VIRGIN ISLANDS WATER & POWER AUTHORITY
TRANSMISSION & DISTRIBUTION DIVISION

PROJECT NUMBER: PR -18 - 20

PROJECT NAME: GOLDEN GROVE UNDERGROUND PROJECT

Addendum No. 1

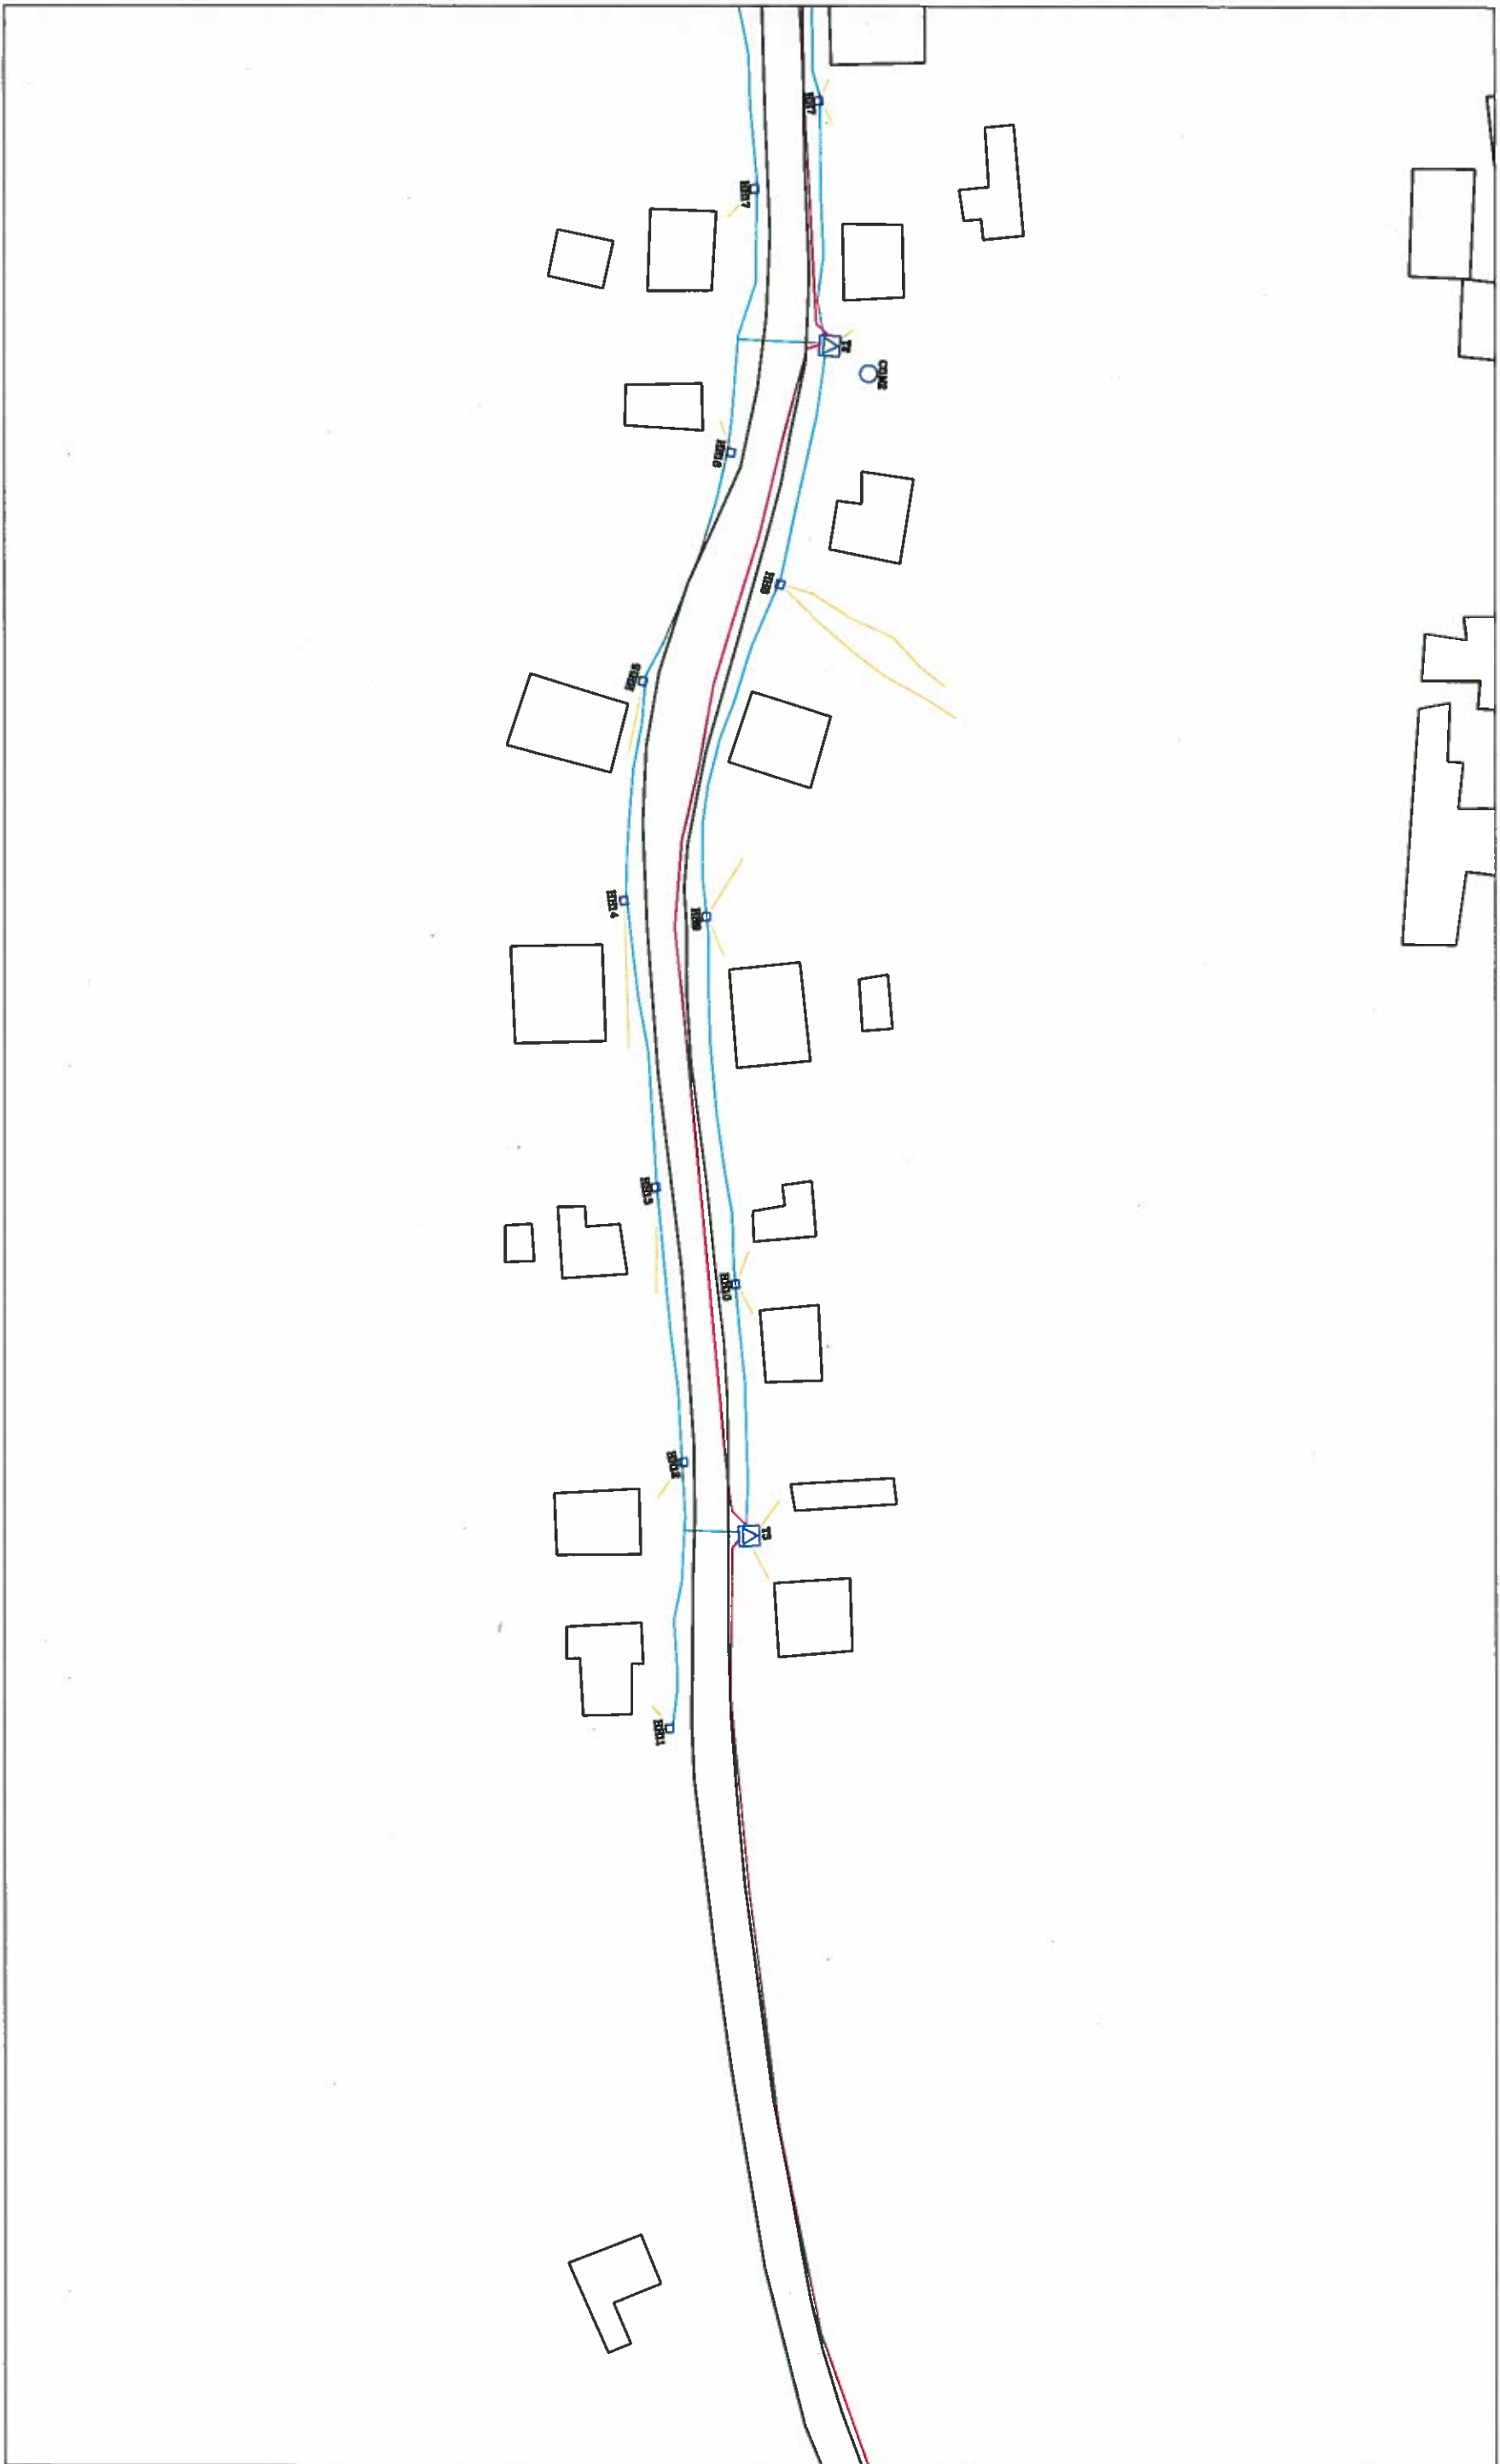
44) On the patch pave, what is the dimensions/overlay required? Is re-paint and fog seal required?

The overlay required is 1/2 or half a lane in order to meet VIDPW specification. See Appendix D along with SKC-01.

Submit strength, quality and gradation specifications for the asphalt mix, include copies of laboratory test reports that demonstrate aggregate, asphalt binder, additives, and mix properties meeting The Federal Highway Administration Standard Specifications for Construction of Roads and Bridges FP-14 Division 400 and VIDPW specifications

- NOTES:
- TACK COAT SHALL BE USED BETWEEN ALL ASPHALT LAYERS AT APPLICATION RATE OF 0.05 GAL/SY.
 - RE-STRIPE ALL PAVEMENT MARKINGS WITHIN OVERLAY WIDTH.

SP
E-3

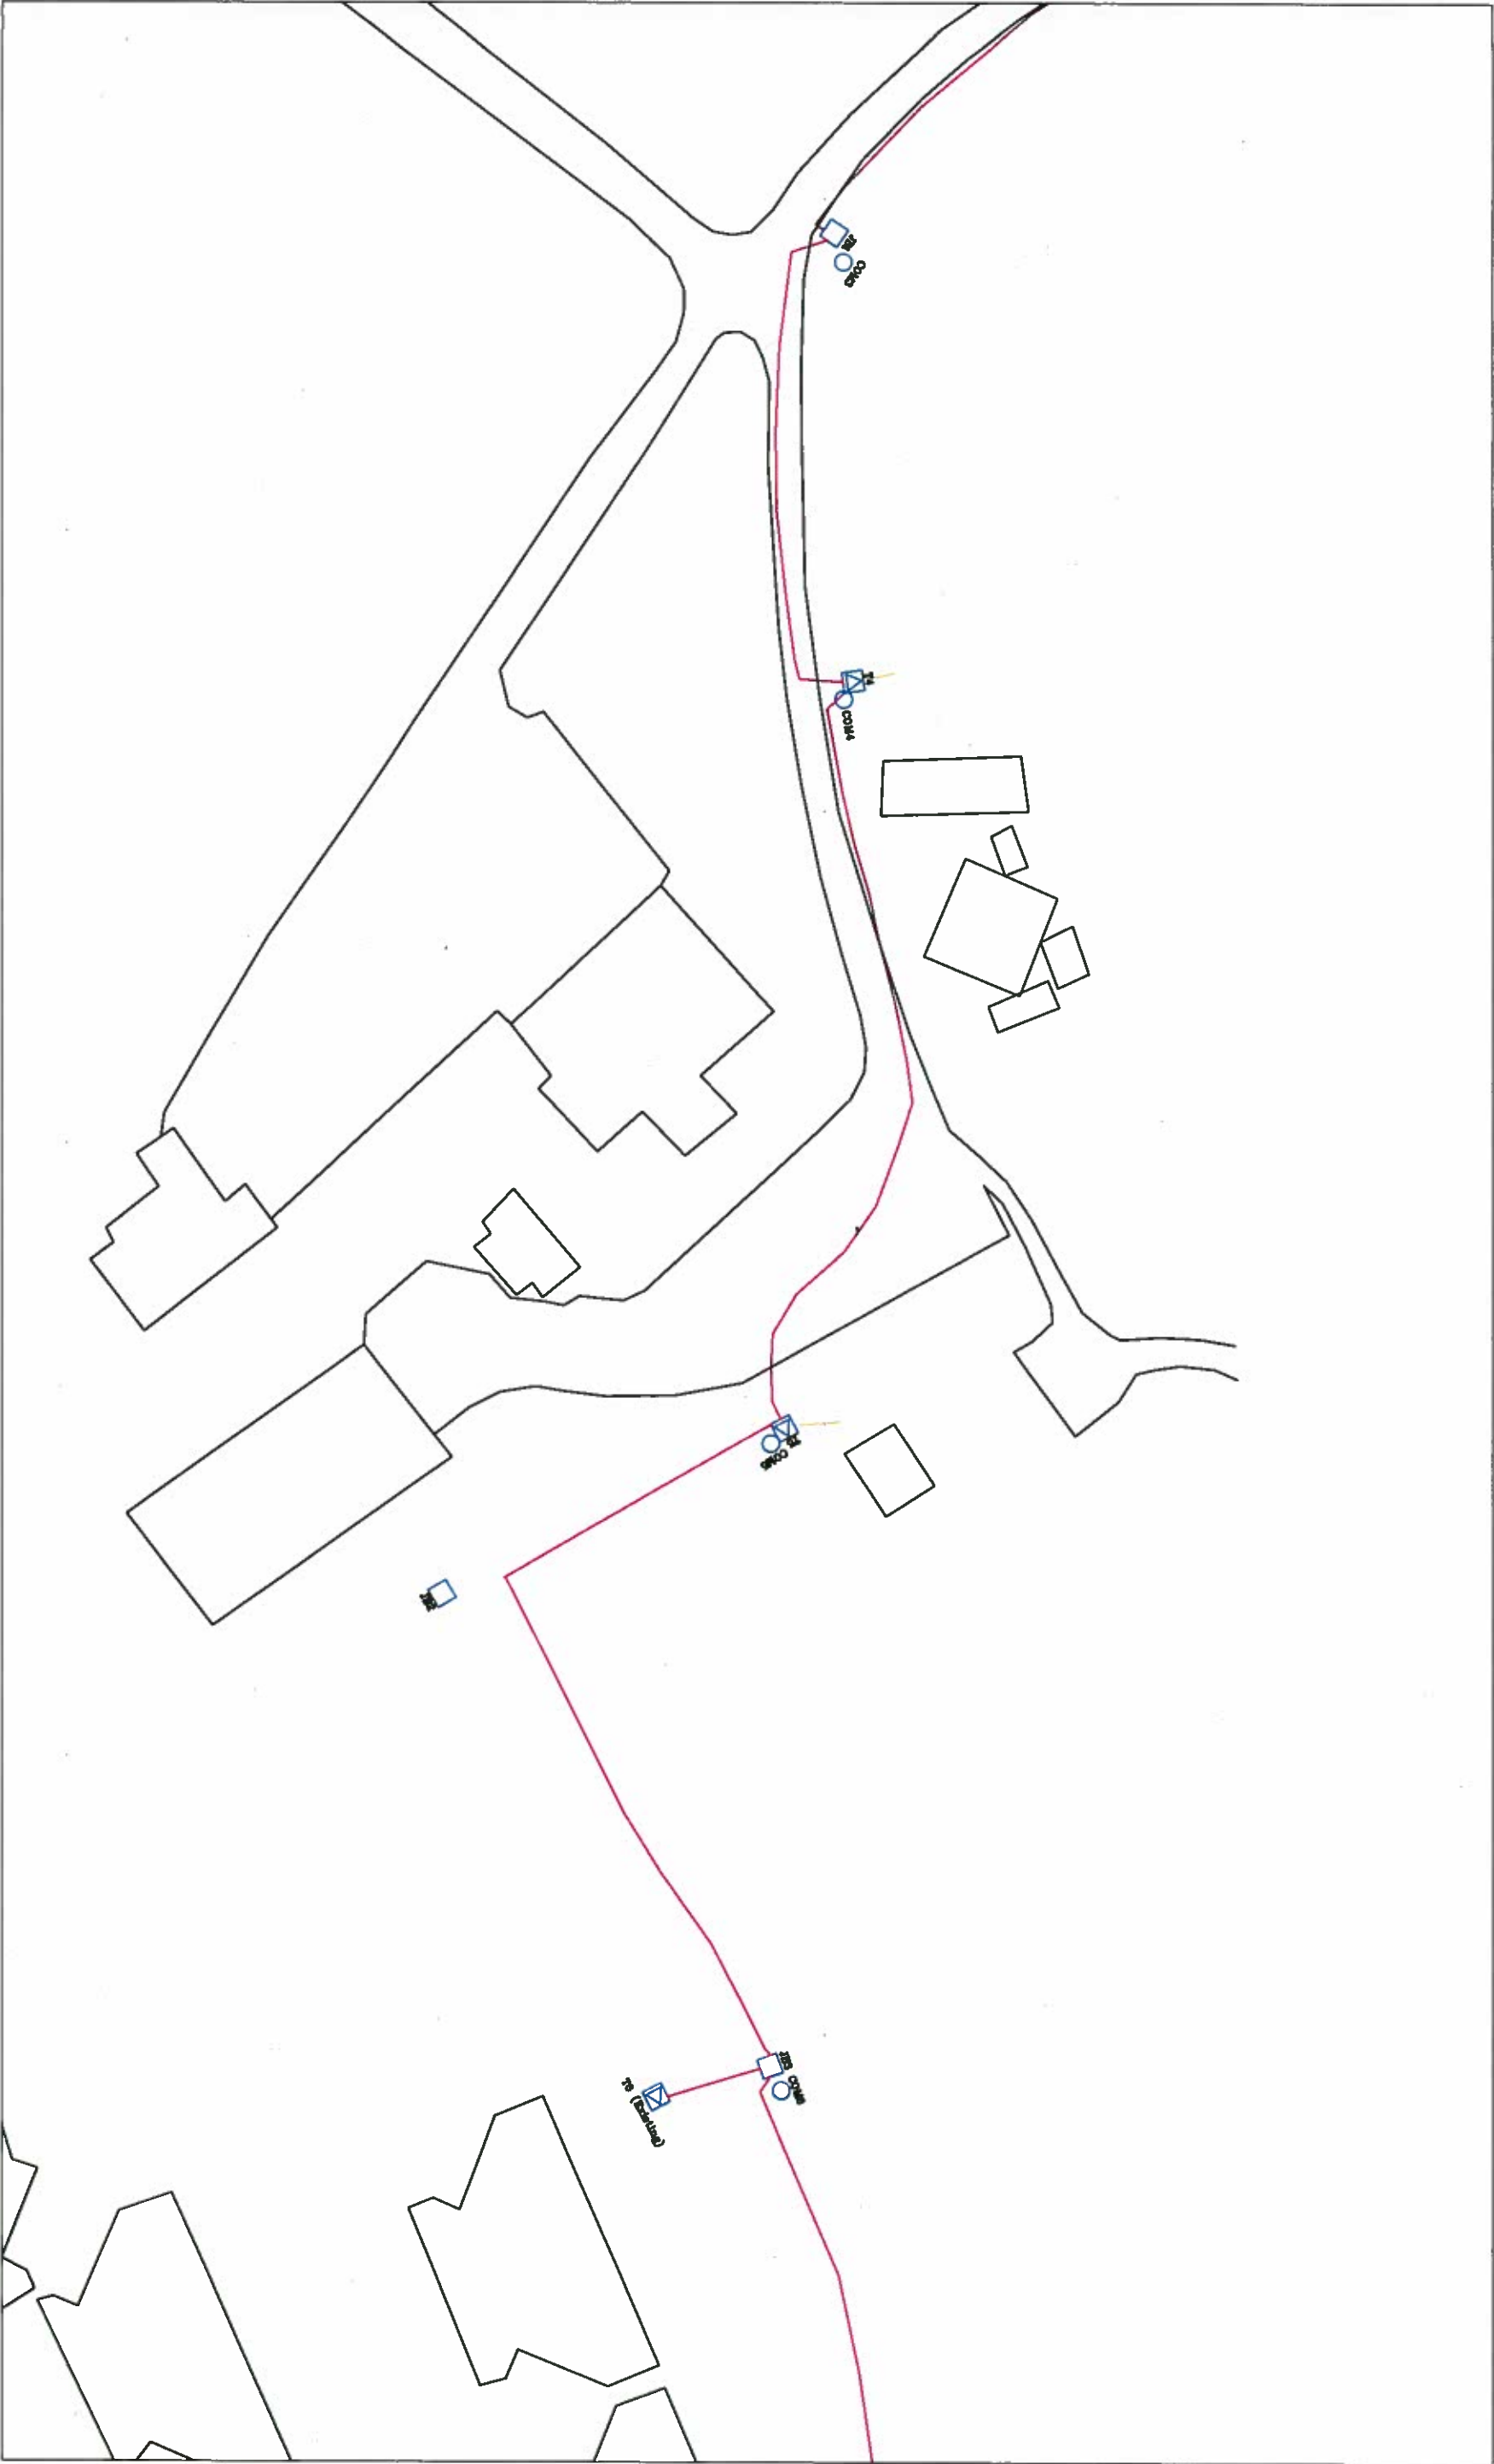
- No RP2 or RP3 (E-3 and E-4)
- No 5' stub out for RP2
- Stub out to feed lights from potentially all transformers and stub out an additional estimated 200' at the DMV for future use
- Hand hole should be 2'x2'x2' (E-8)
- 8 Communication Manholes
